Subject: SOFT TOP LATCH AND/OR COVER RATTLING	Bulletin No: 09-021/08
	Last Issued: 7/30/2008

This bulletin supersedes the previous bulletin 09-028/07, issued 7/18/2007. The WARRANTY INFORMATION has been revised.

2006-2007 MX-5 with VINs lower than JM1 NC**** ** 134259 (built before January 15, 2007)

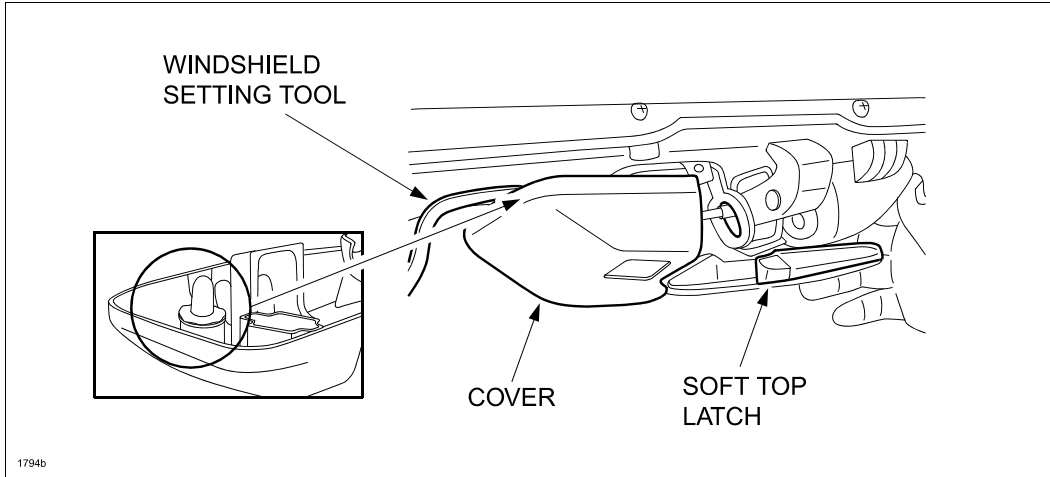
As a mass production change to prevent the noise, a pad has been attached to the location where the soft top cover is making the noise. Customers having this concern should have their vehicle repaired using the following repair procedure.
